Staff Report

Case #: SUB-2015-10-00027

A Resolution to Approve Preliminary Subdivision request by GCHP-Hammond LLC for Phoenix Square Phase II Major Subdivision including Approval of Preliminary Plat & Construction Plans by Clay Barrilleaux, PE, dated 11/30/2015 (Case#SUB-2015-10-00027) Recommend approval with conditions by the Planning Commission (Josh Taylor)

RE: Preliminary Subdivision Review
Phoenix Square Subdivision – Phase II
Sec. 26, T6S, R7E (44 lots)

Post Construction Drainage Flows Sheet 5 of 8

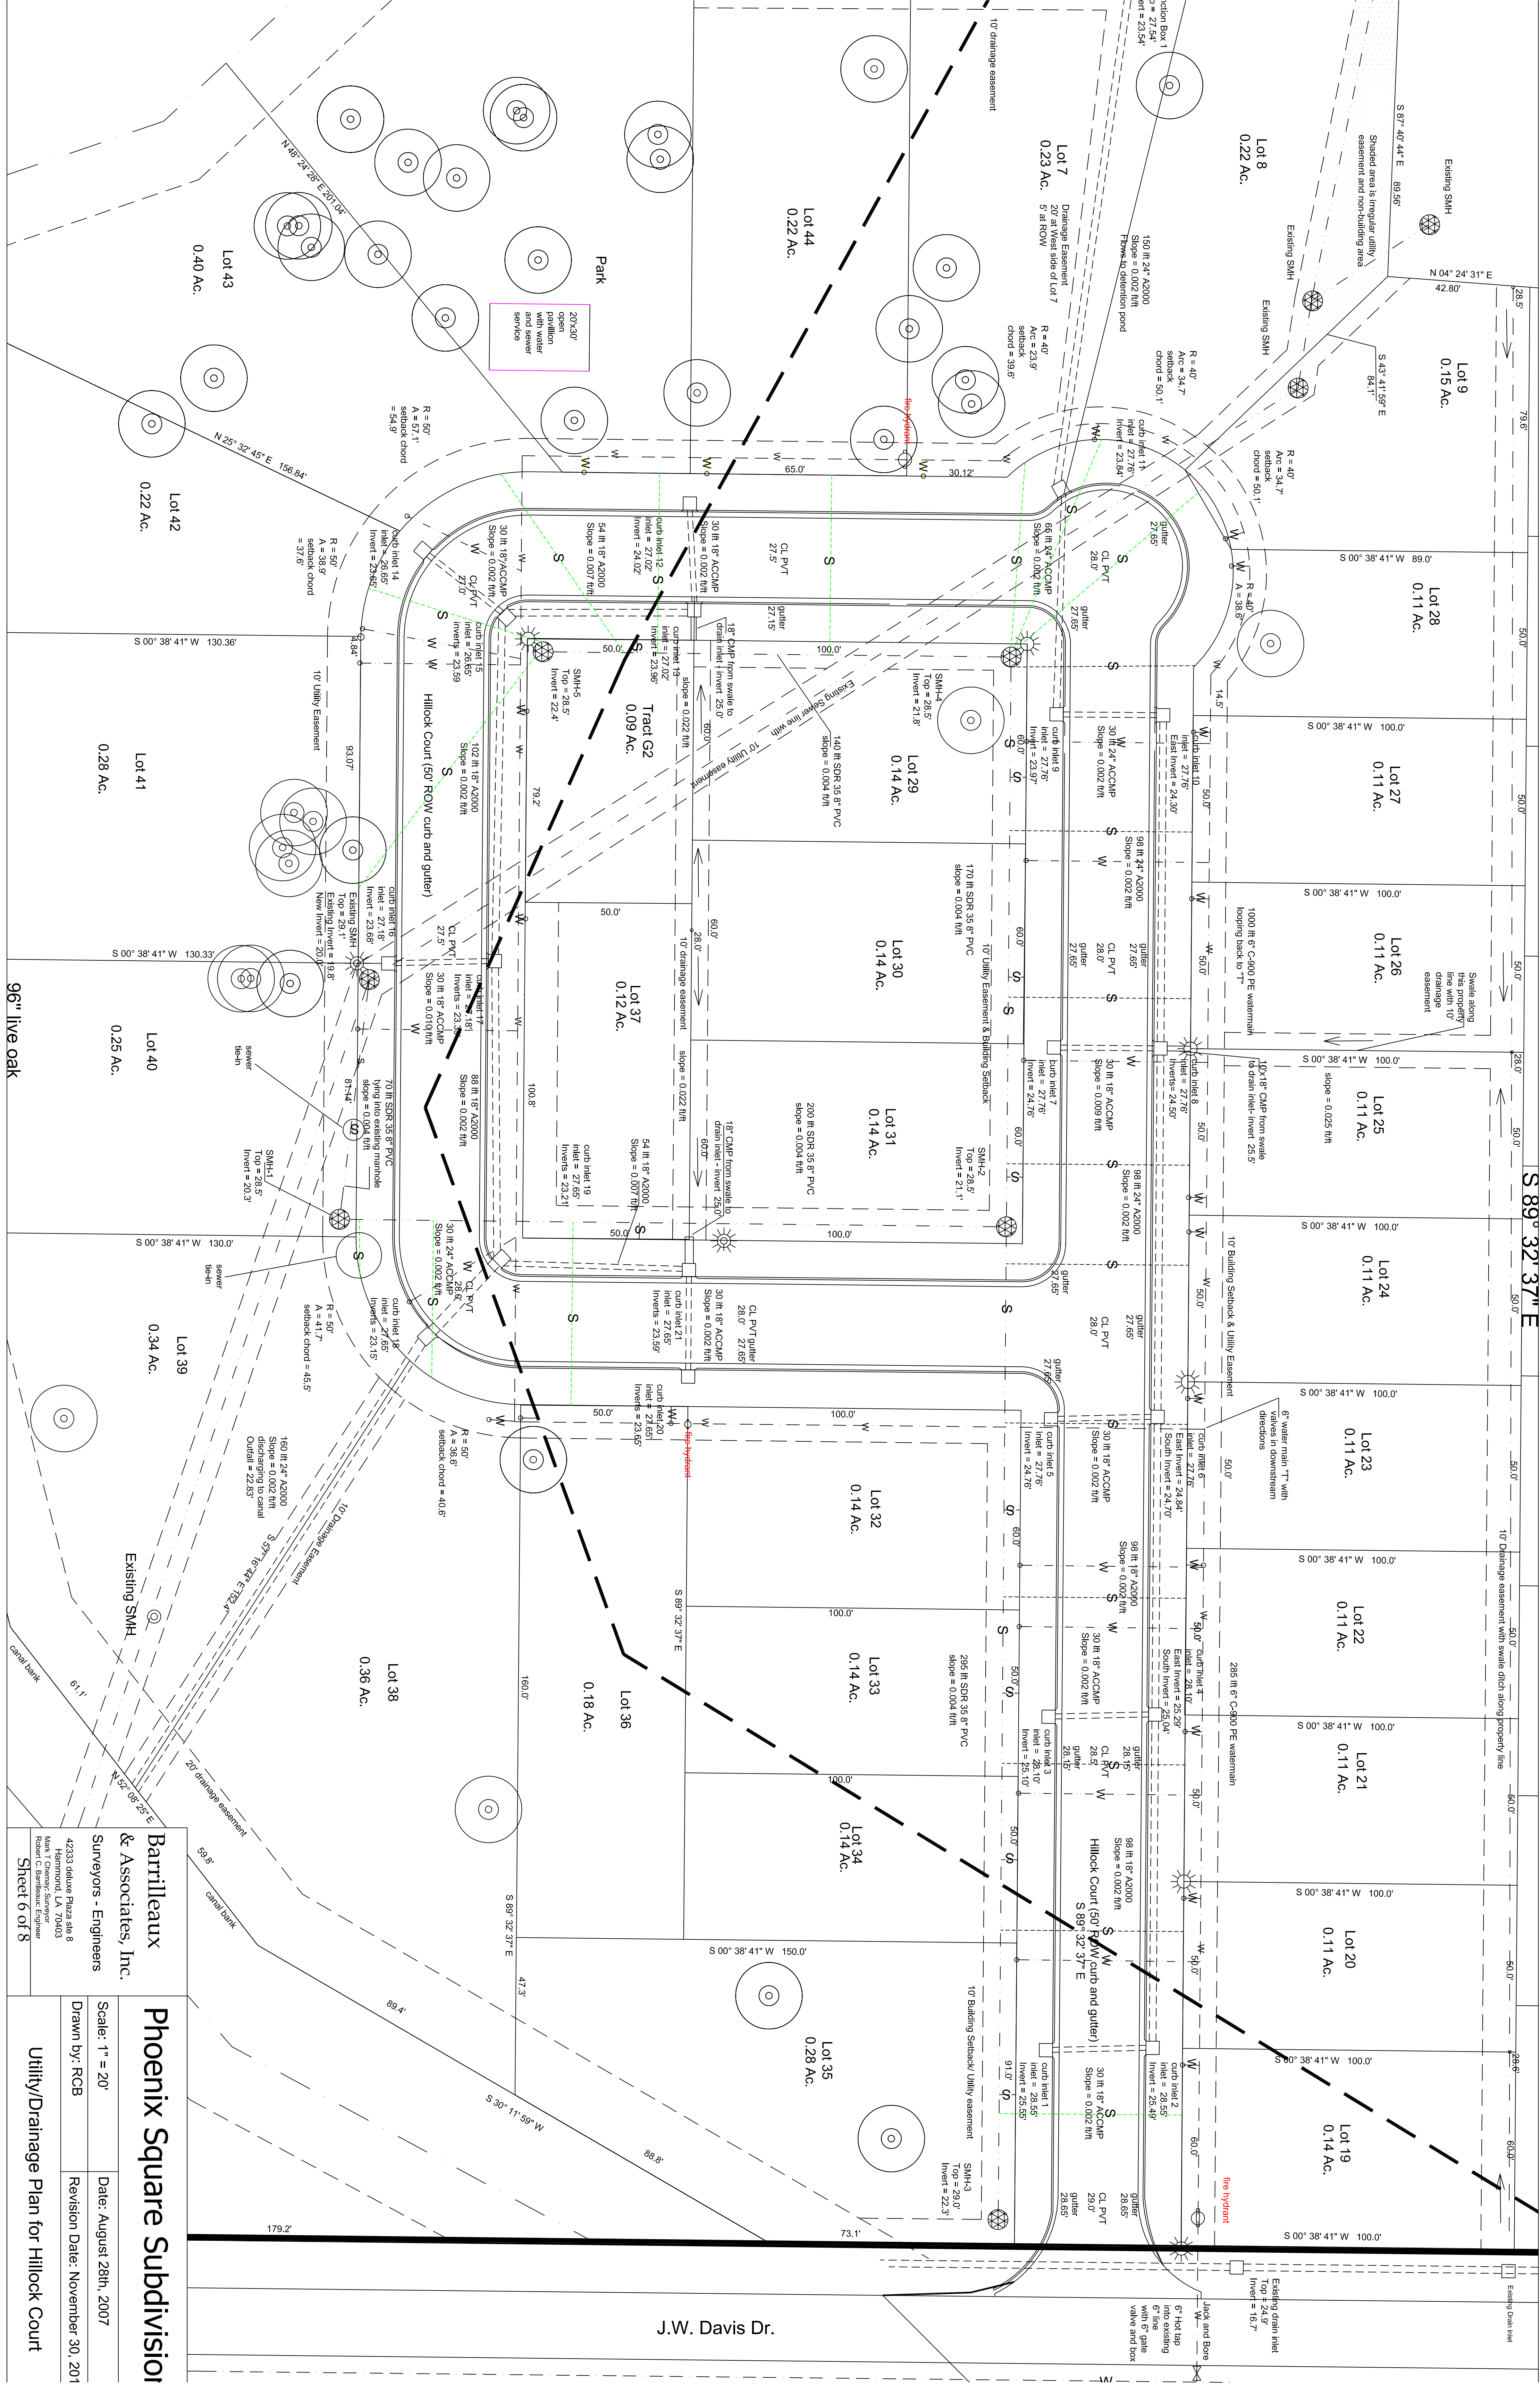
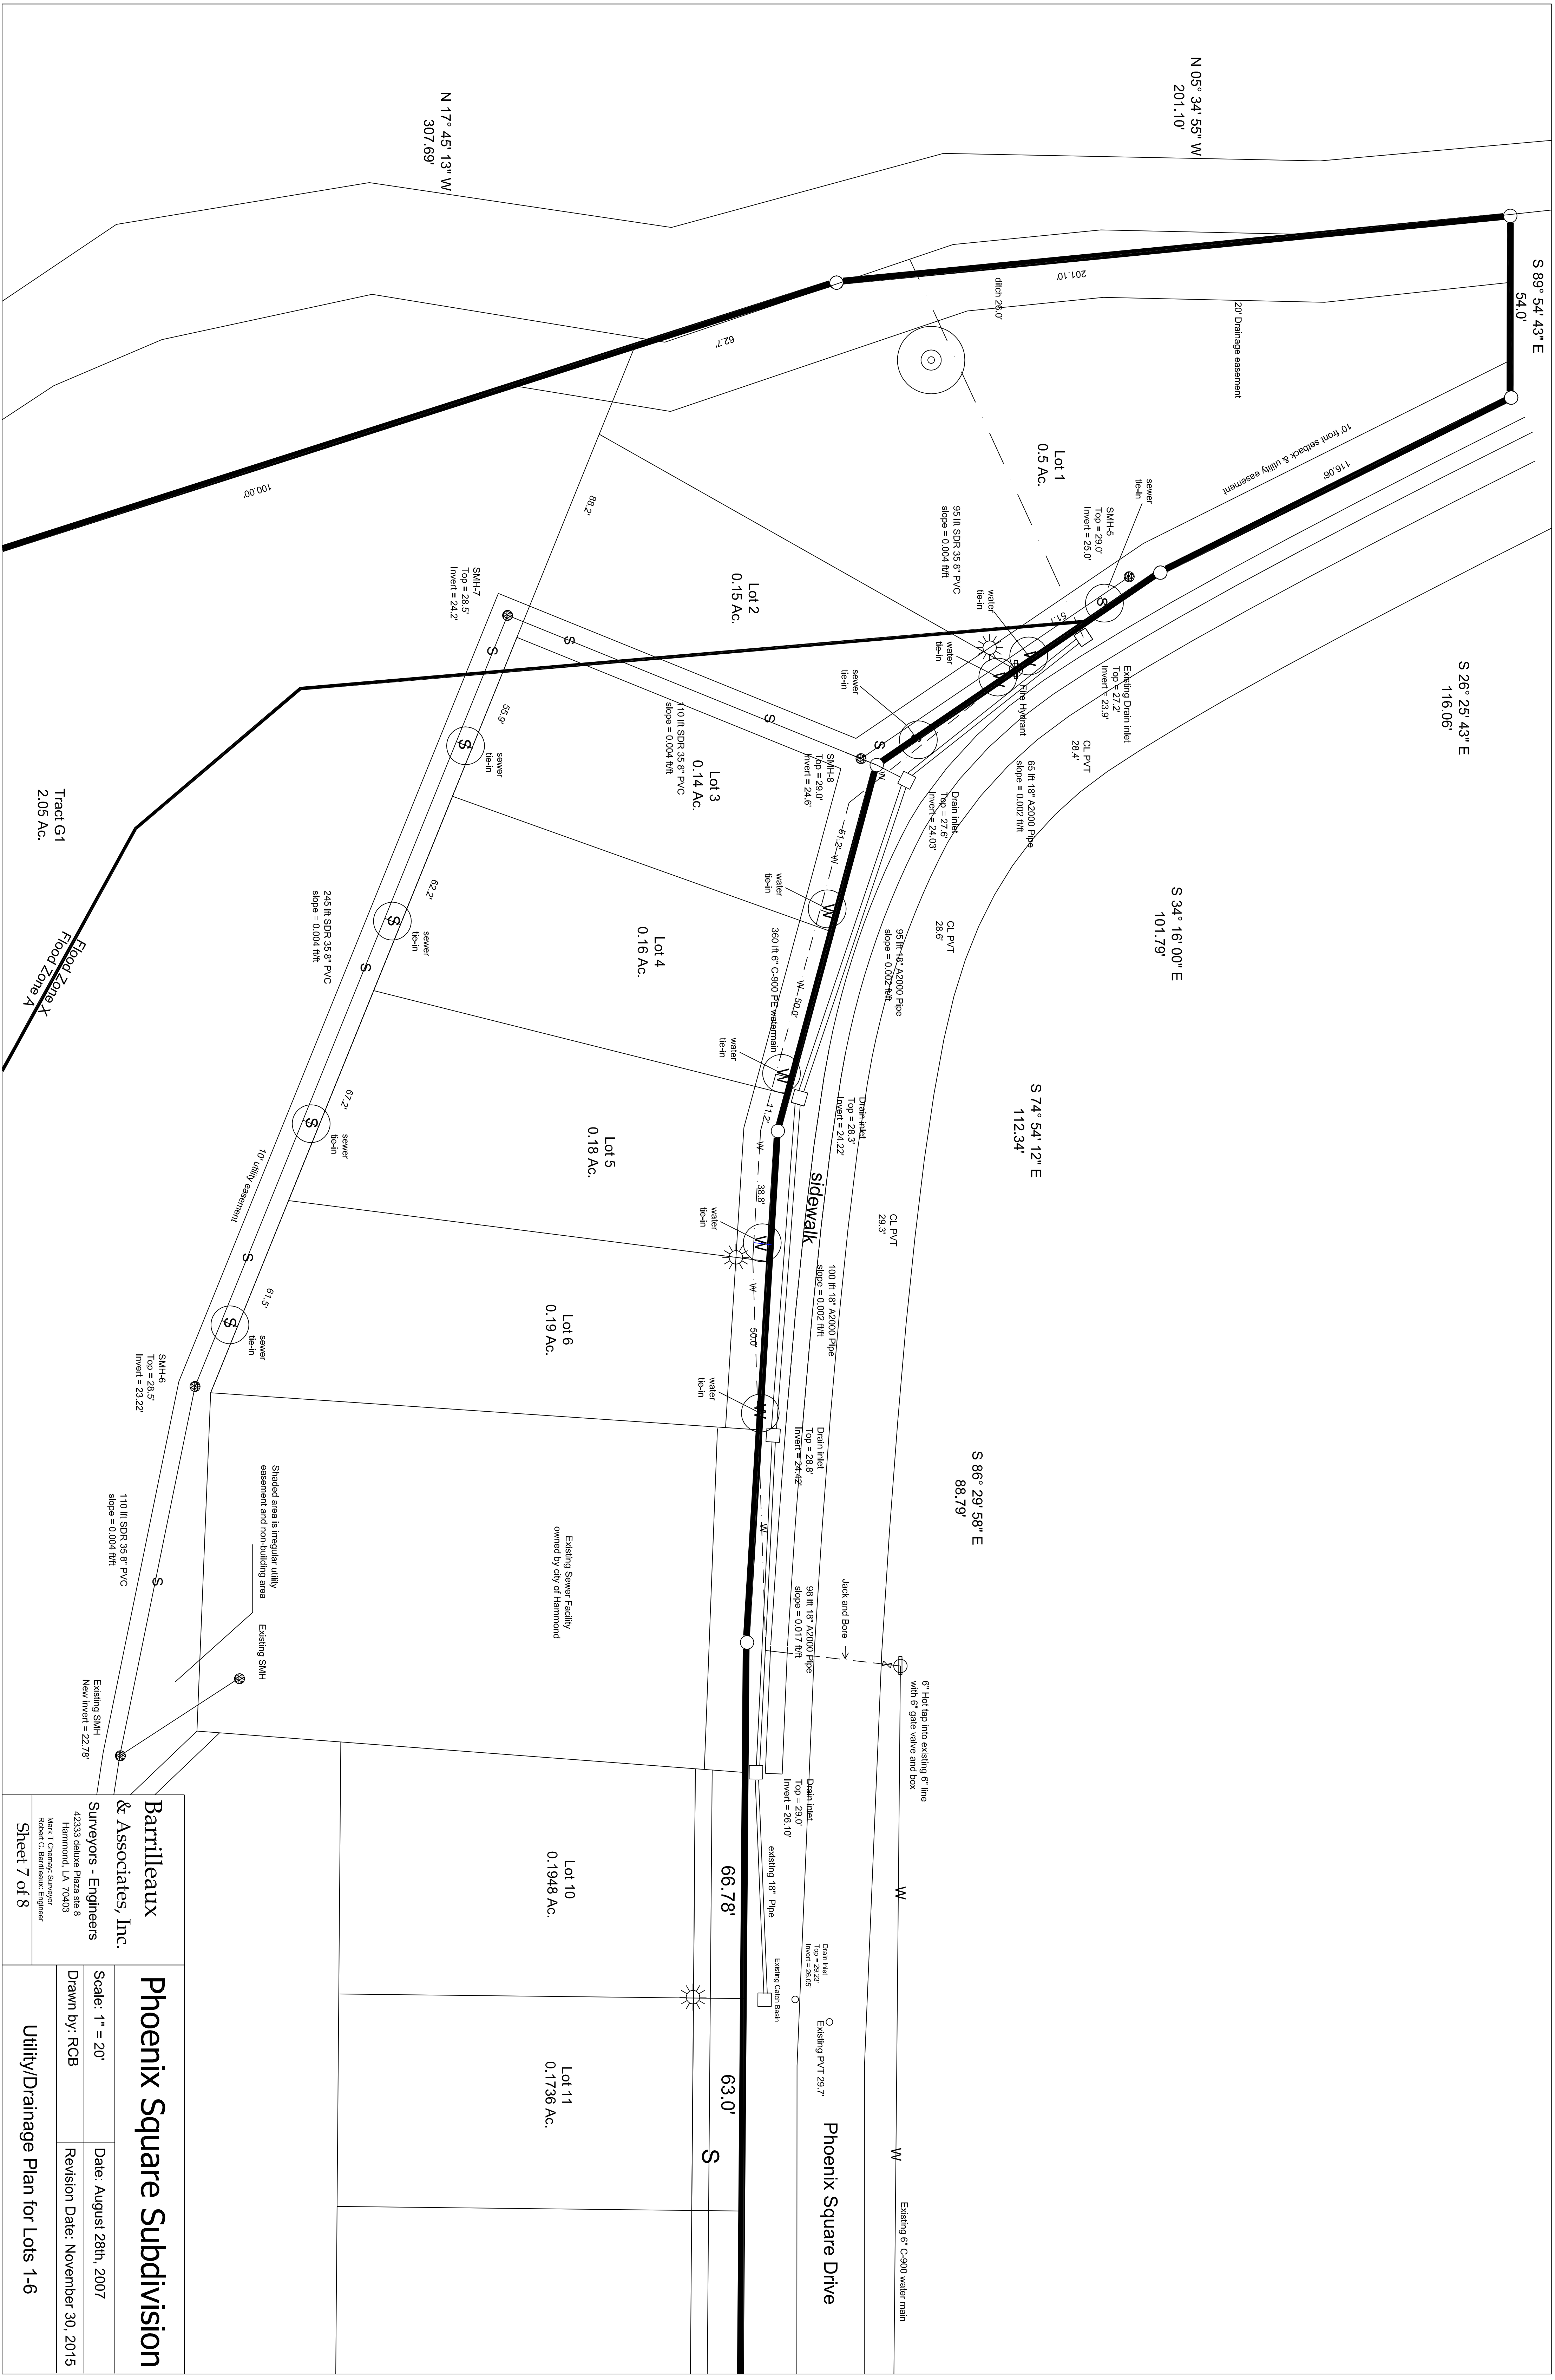
1. A dry detention pond is proposed. Dedicated access to the pond should be shown.
2. See comment "2." under "General" above.
3. Sheet "C-3" shows catch basin "D9" outfalling to the Detention Pond; the "Post Development Drainage Plan" sheet shows catch basin "D8" as the outfall CB.
4. The "Drainage Notes" indicates the Detention Pond outlet pipe to be "12 inch" diameter to minimize discharge; the actual drawing shows "18" A2000 outfall pipe" as the Detention Pond outlet pipe.
